NOTICE OF ADDENDUM
ADDENDUM NO. 3
City of Madison, Engineering Department

CONTRACT NO. 8981
METRO TRANSIT PHASE 3A – MAINTENANCE AND DRIVER FACILITY IMPROVEMENTS

This addendum is issued to modify, explain or correct the original Drawings, Specifications, or Contract Documents marked as *Metro Transit Phase 3A–Maintenance and Driver Facility Improvements, City of Madison, Contract #8981, as issued on April 8th, 2021* and is hereby made a part of the contract documents.

SHEET NO.:
S-001

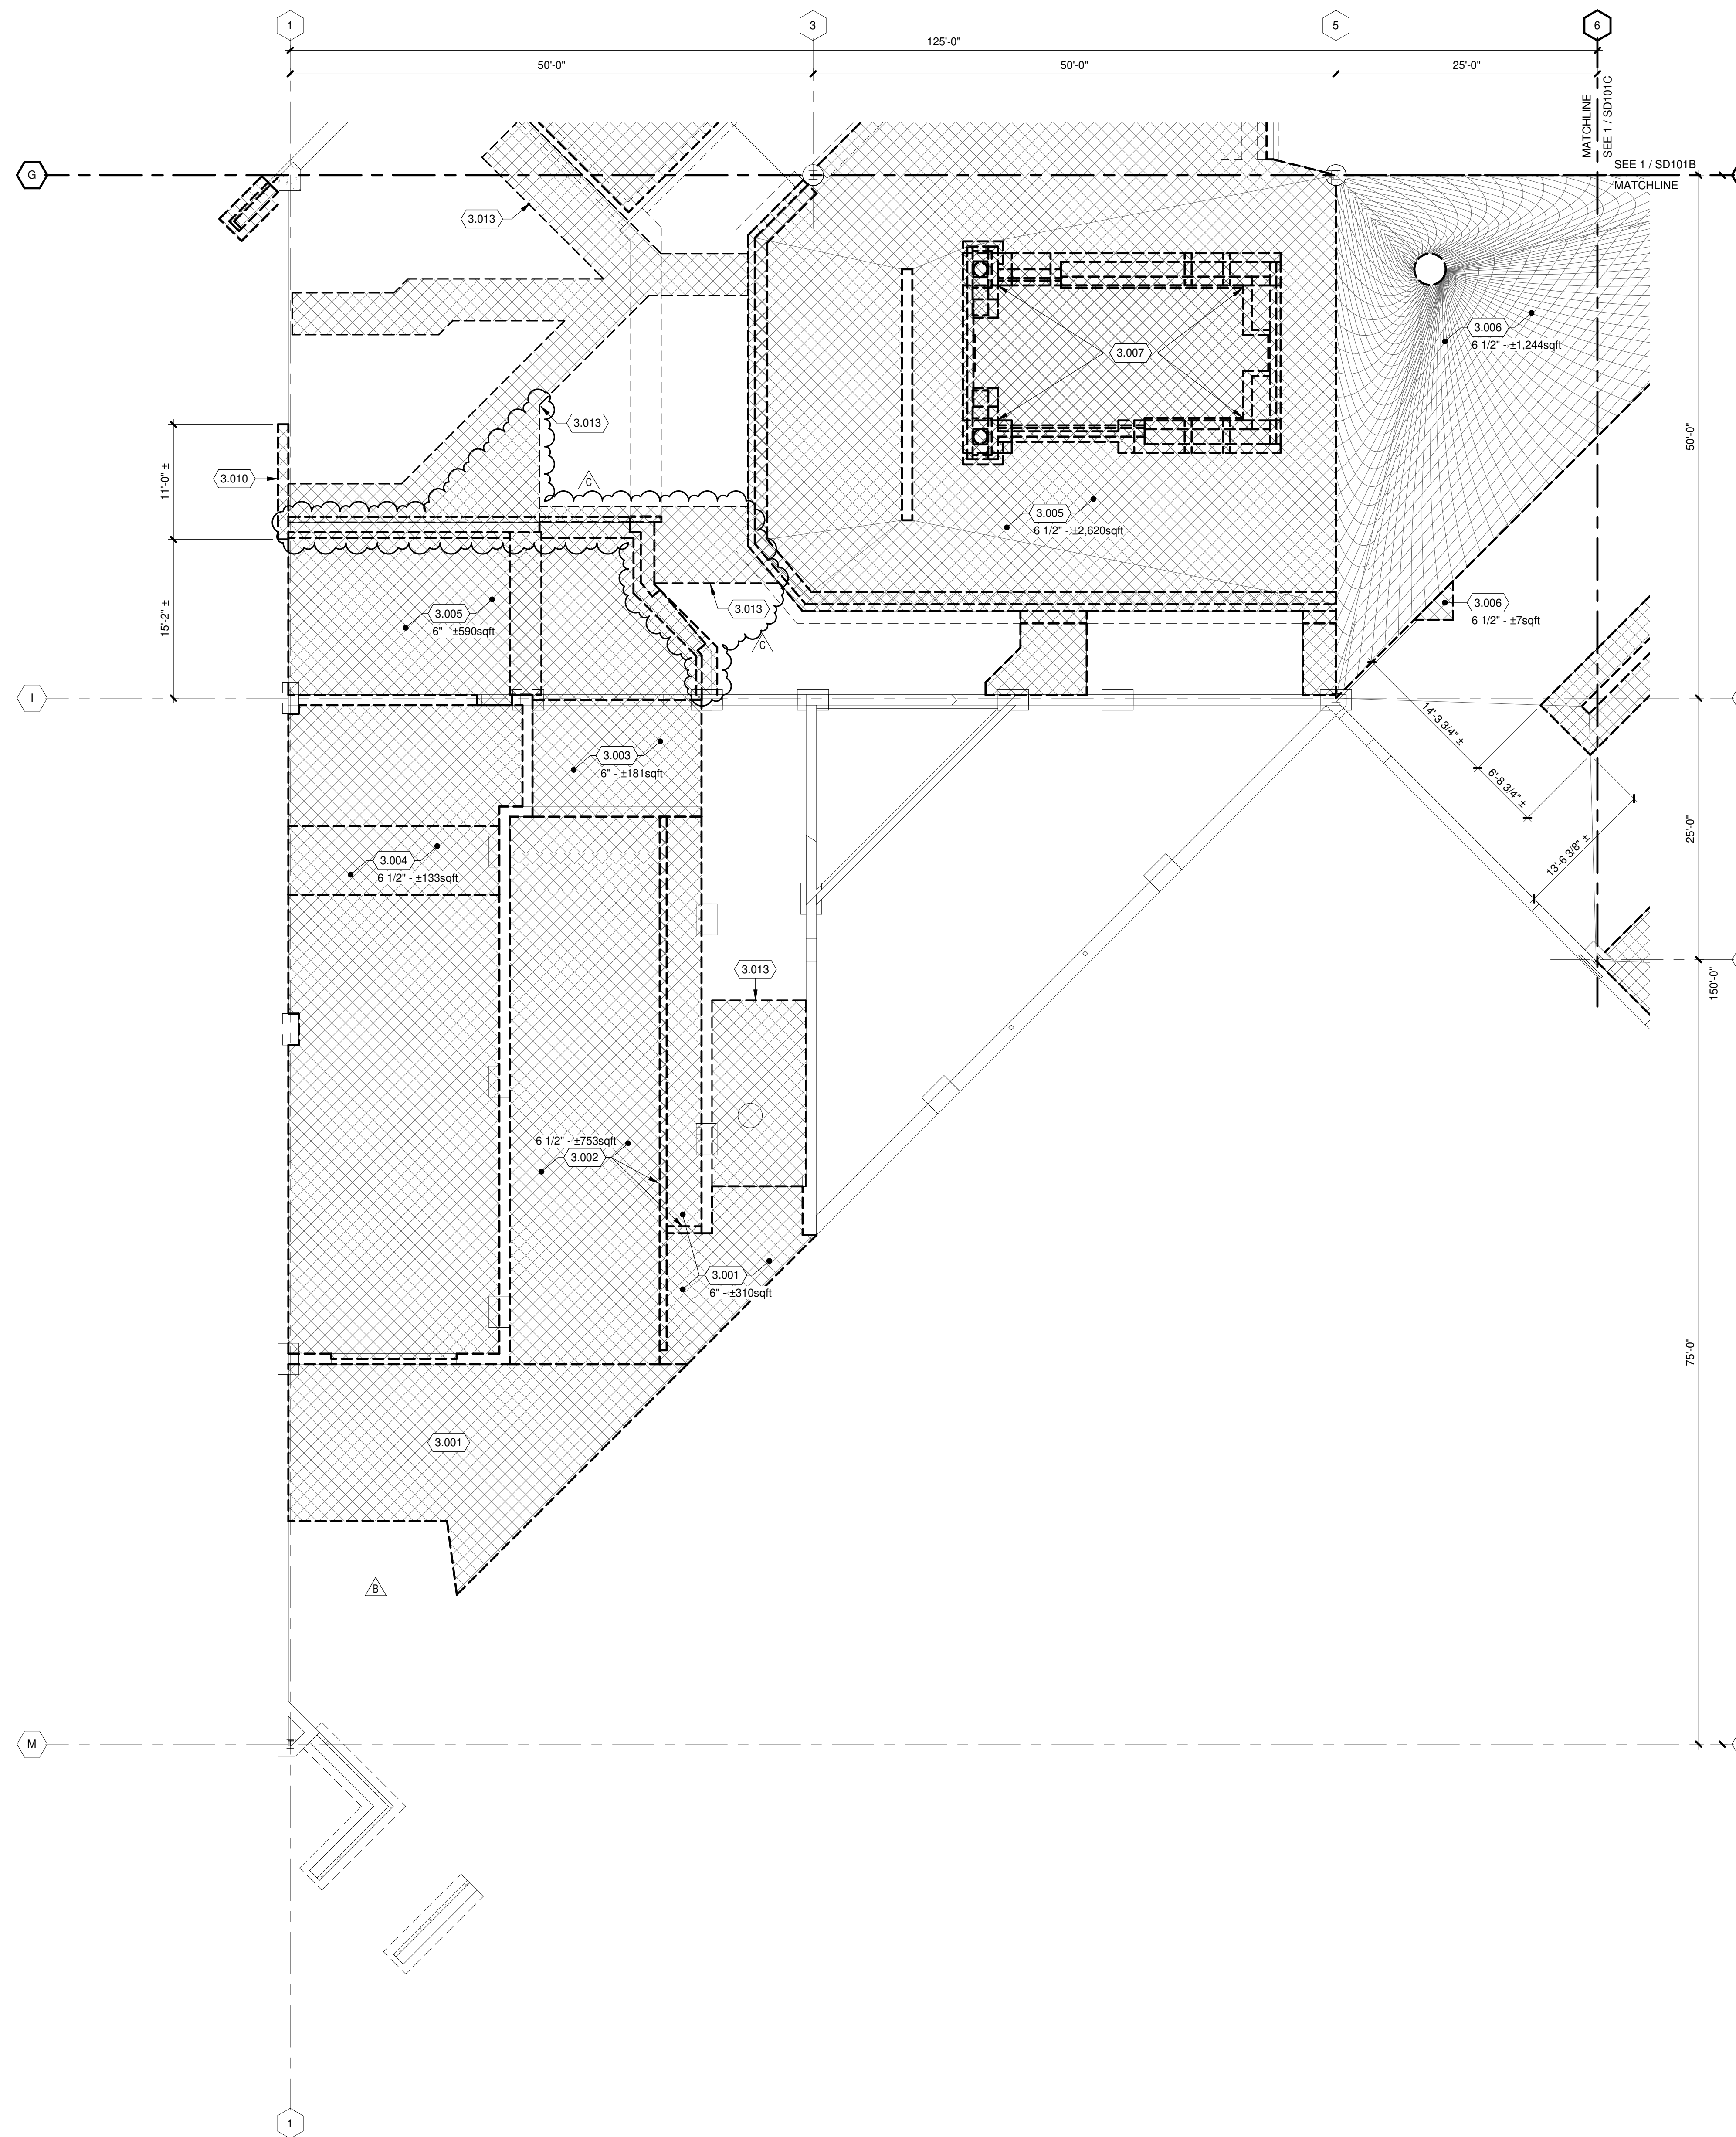
- i. Drawing S-001 (attached); Add control joint symbol to General Symbols
- ii. Drawing SD-101A (attached);
 - Add demolition of grade beam
 - Add demolition of additional slab on grade

S-111A

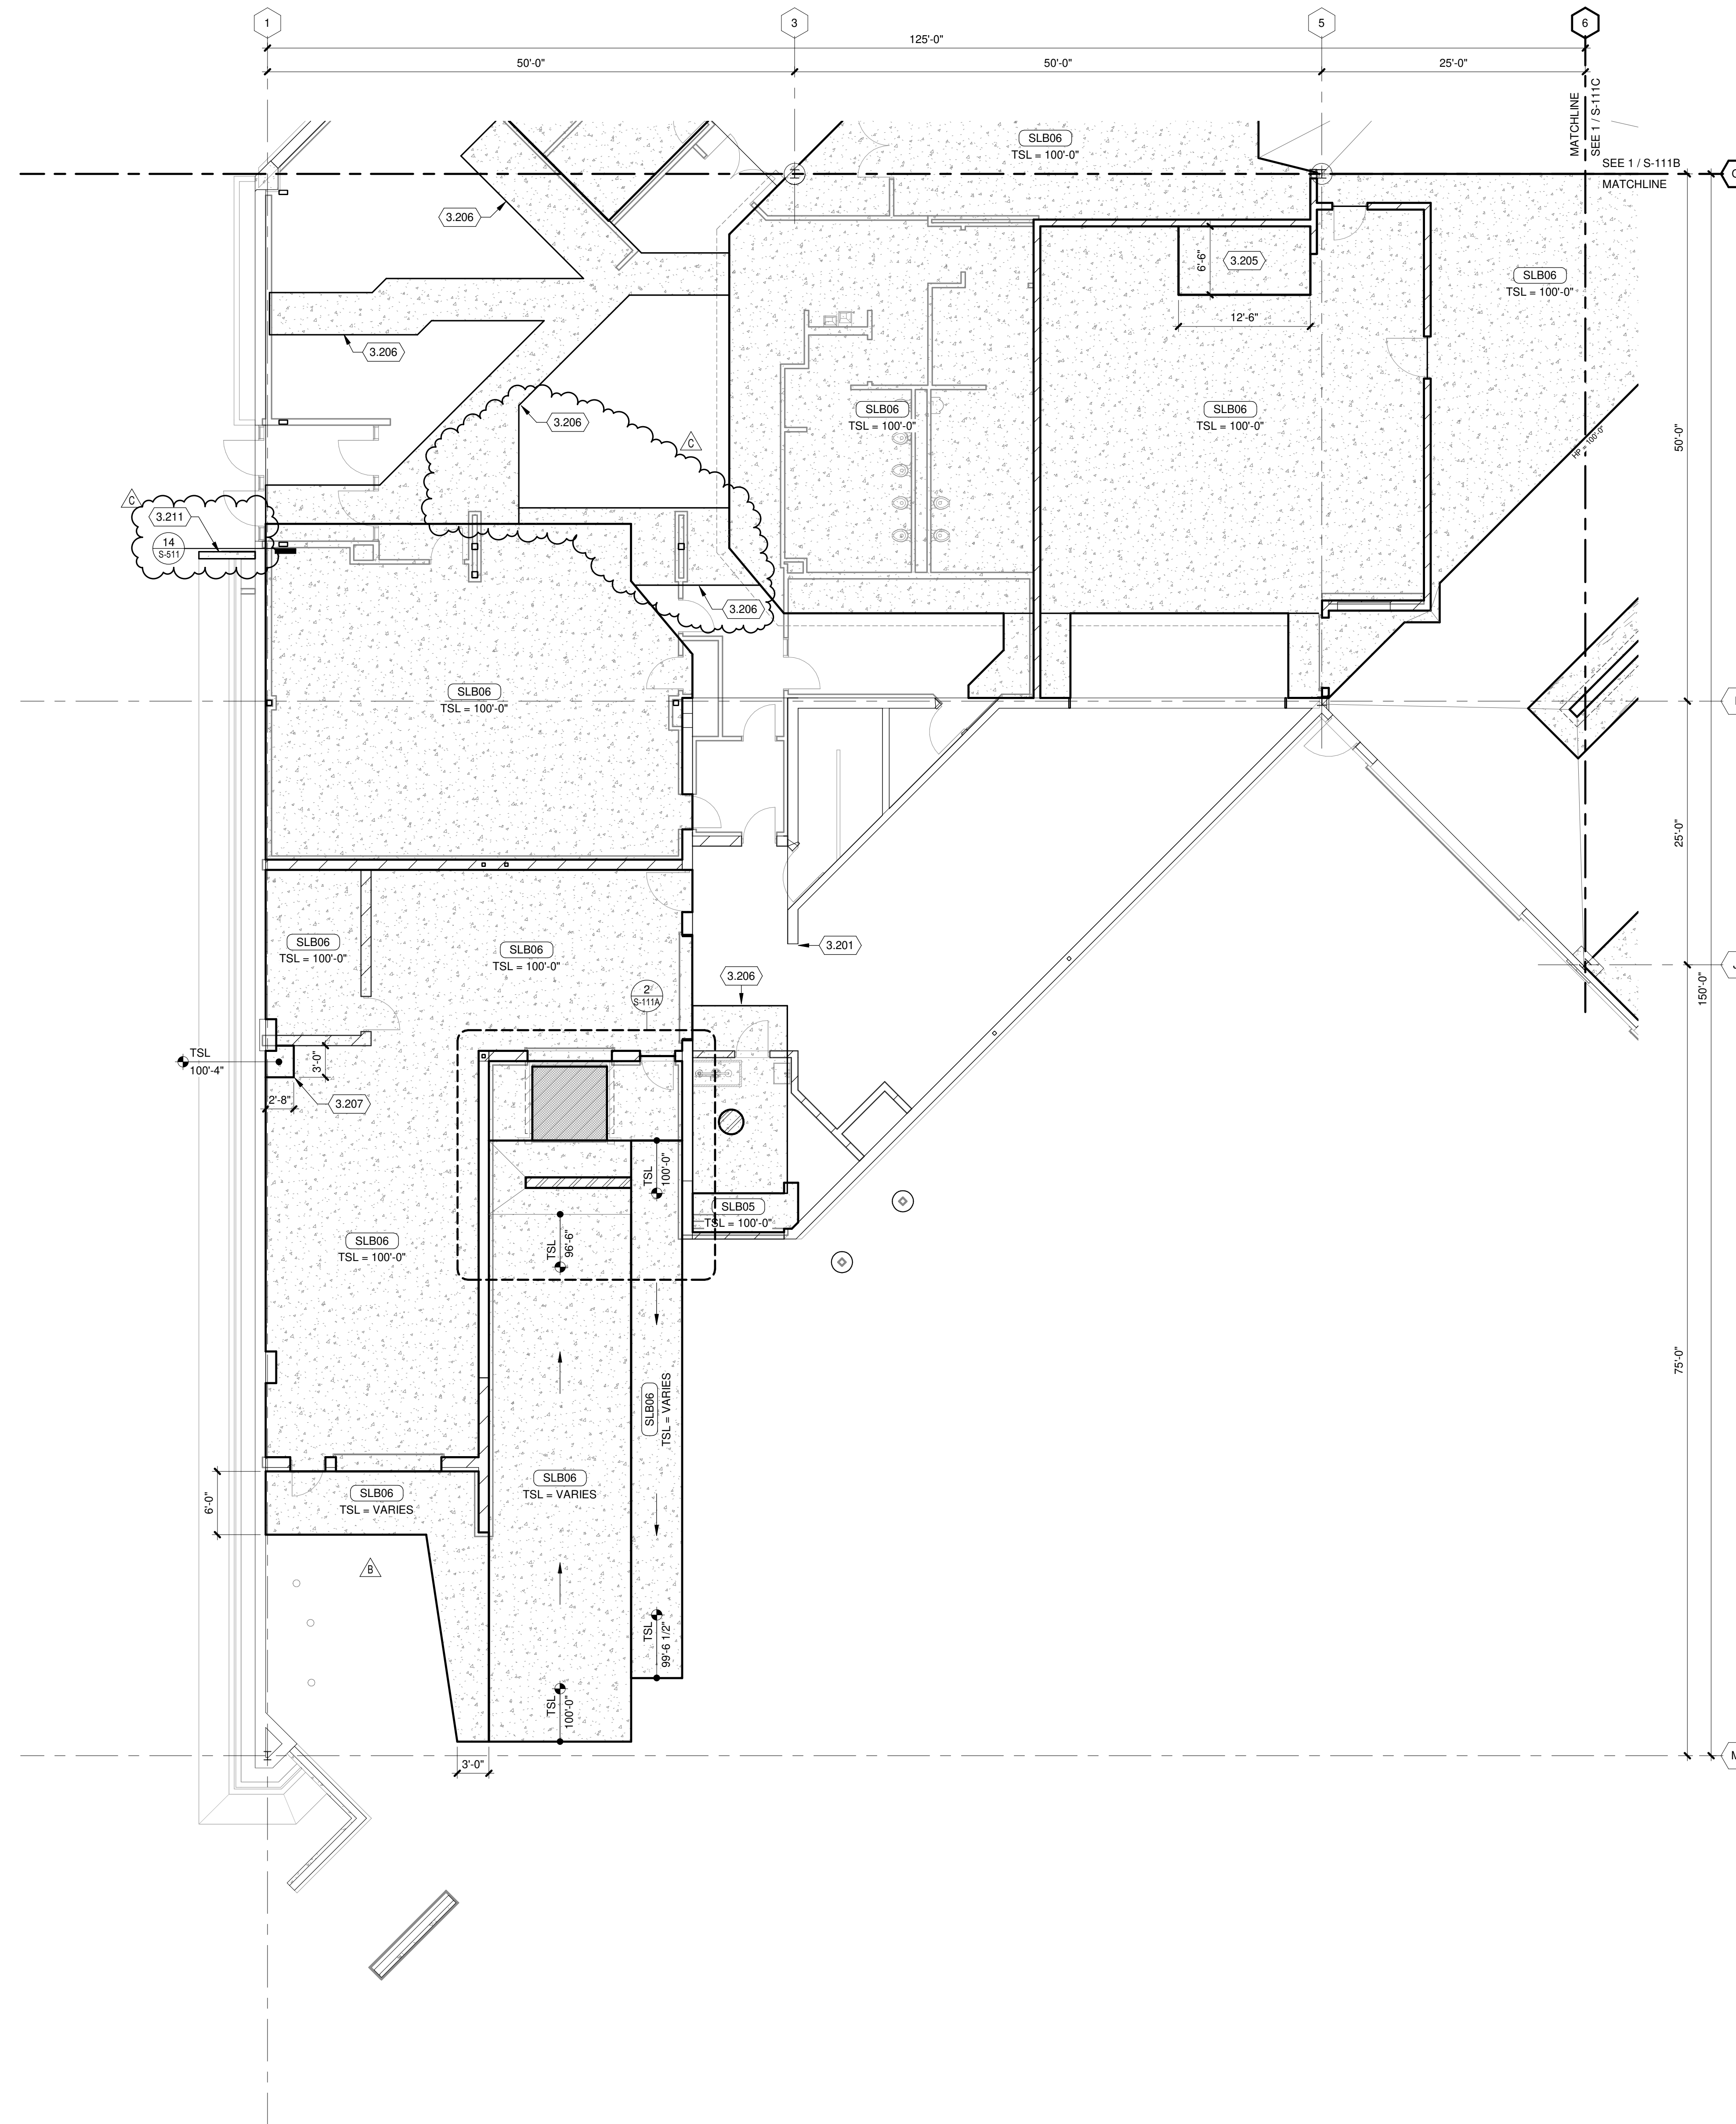
- Add short grade beams
- v. Drawing S-111A (attached)
 - Add slab on grade, interior
 - Add concrete end cap to landscape feature, exterior, at main employee entrance

S-151C

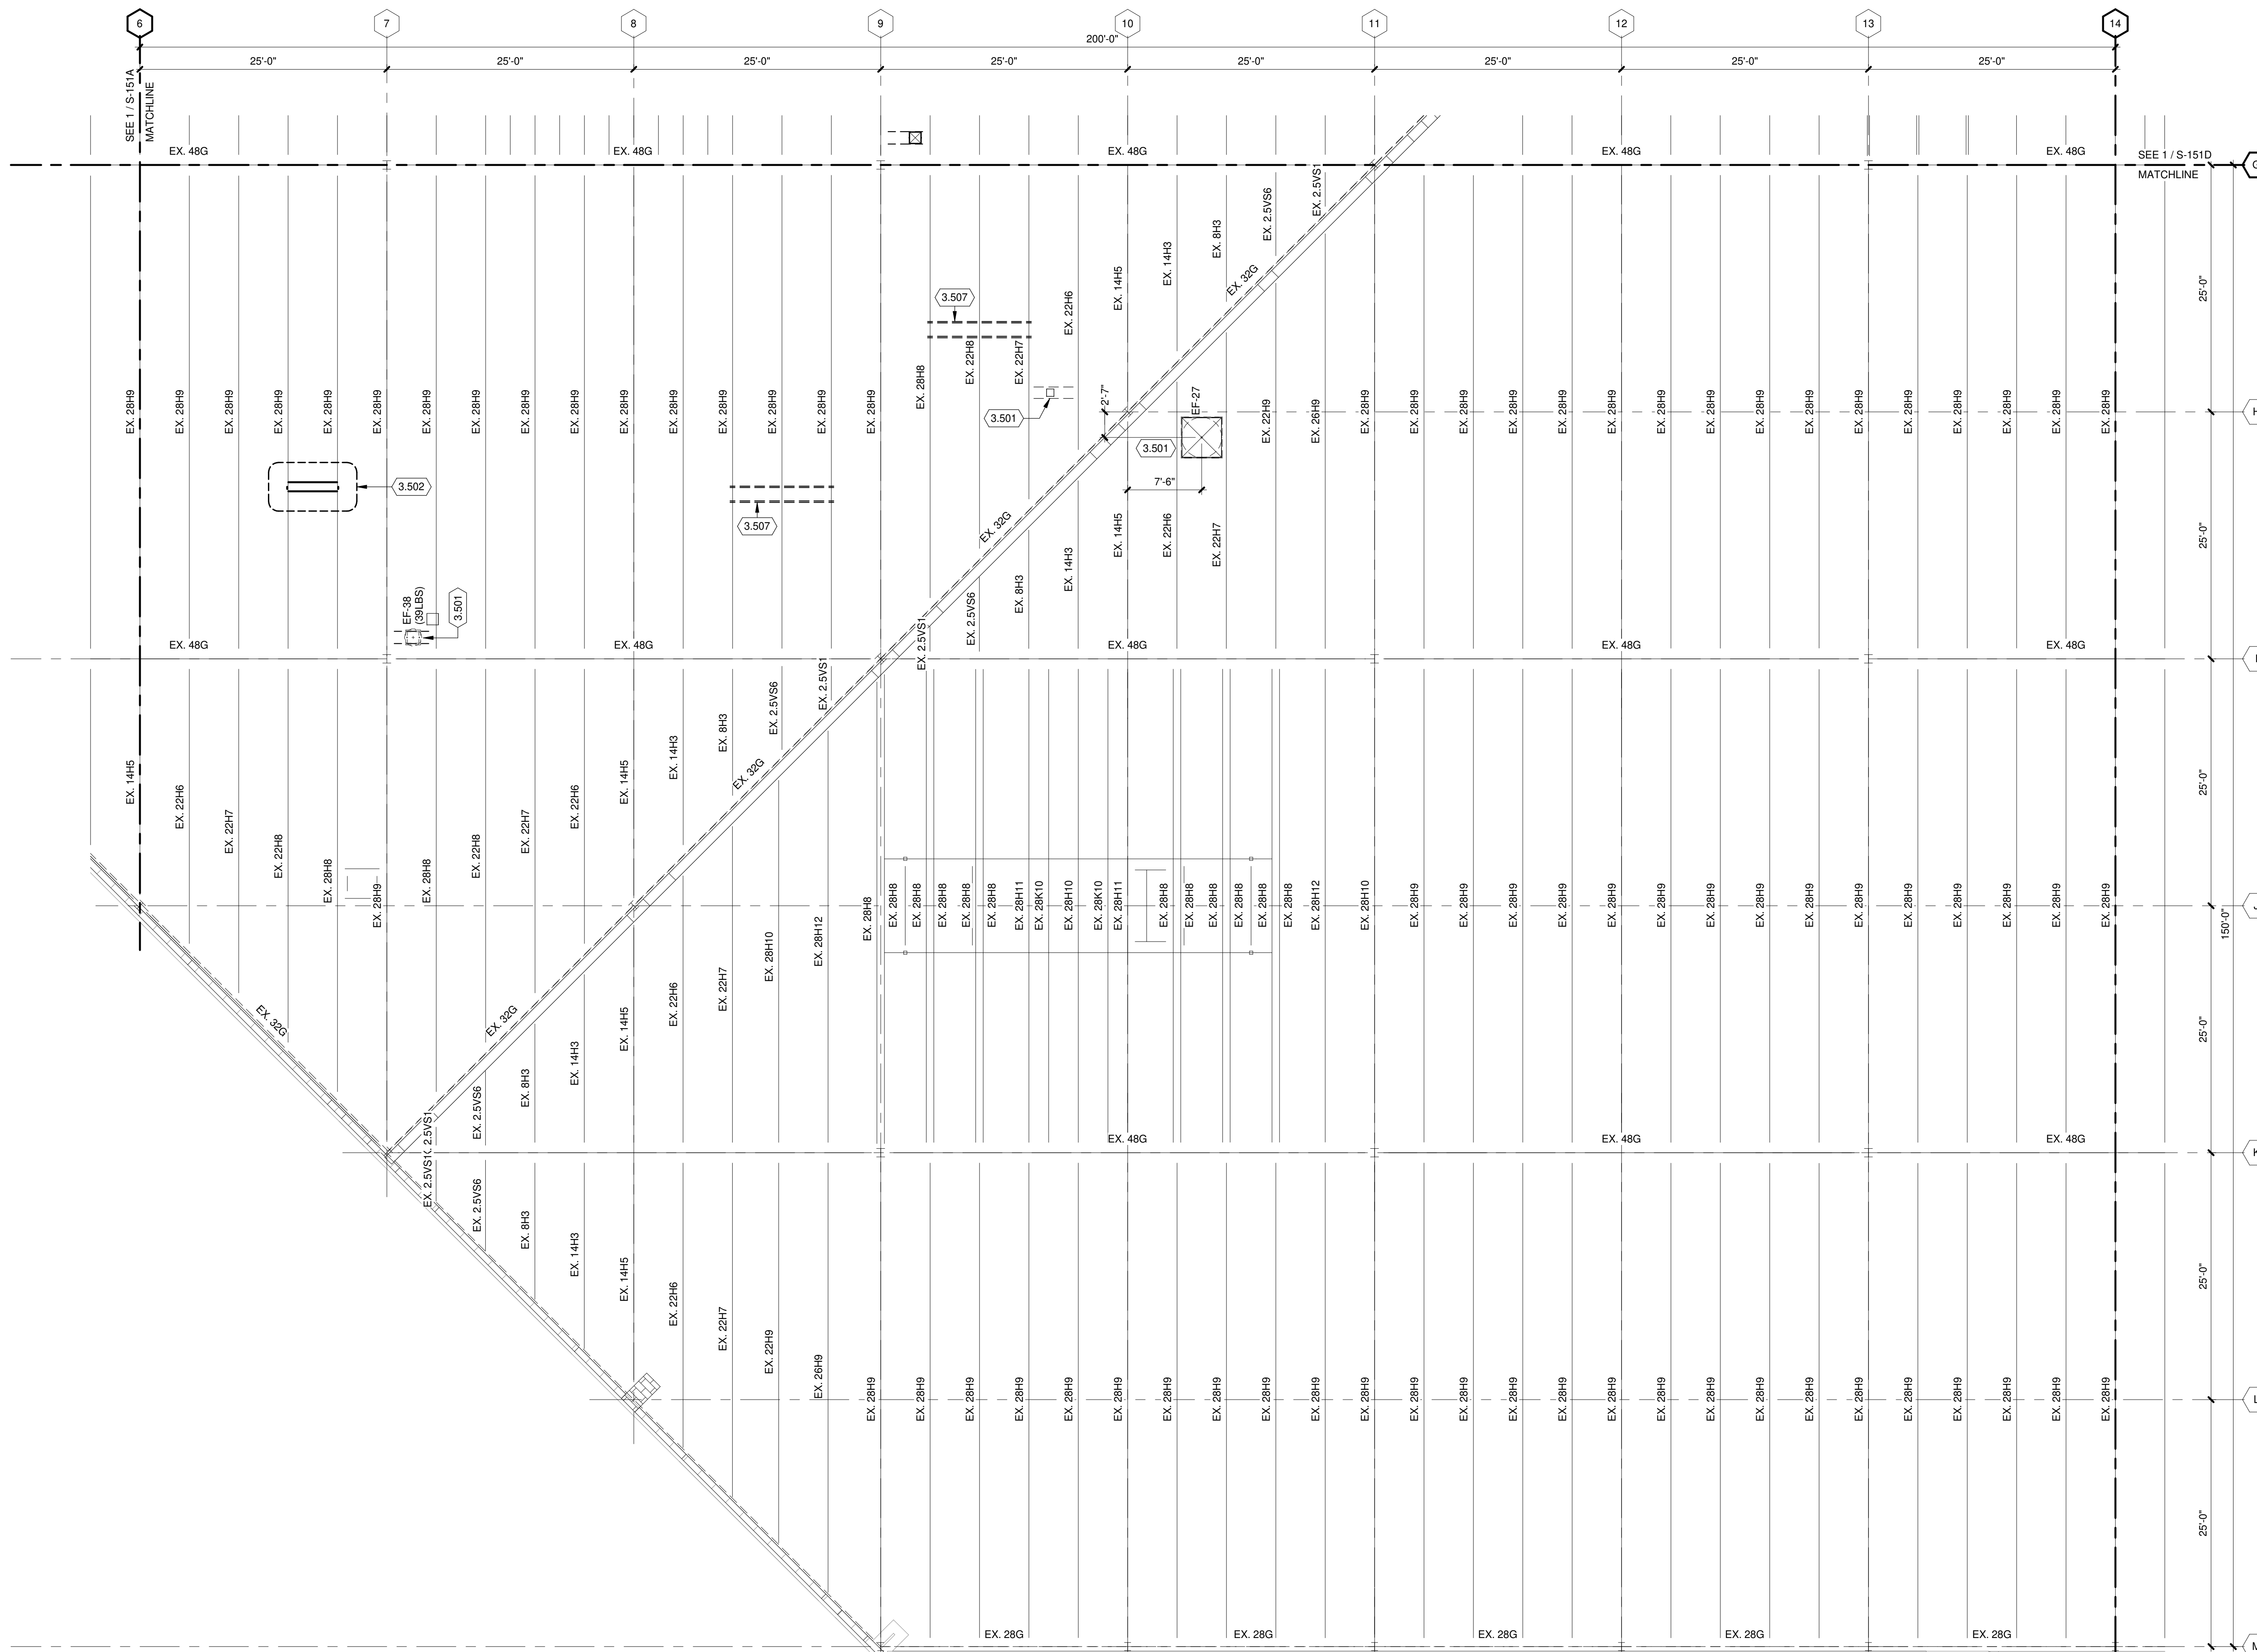
- Modify keyed note 3.506
 - Add roof framed opening
 - Changed elevation of (3) W12x40 beams
- viii. Drawing S-151C (attached)
 - Modified keyed note 3.507 – added detail reference for Trapeze Framing.

- Each reel will require a Lincoln Model 85242 Heavy Duty Reel Mounting Kit. This mounting kit will attach to the structural angles provided in detail 16/S-541 at each reel bank (also see sheets S-151C and S-151D, keyed note 3.507). Alternate reel manufacturers may require a unique mounting bracket.
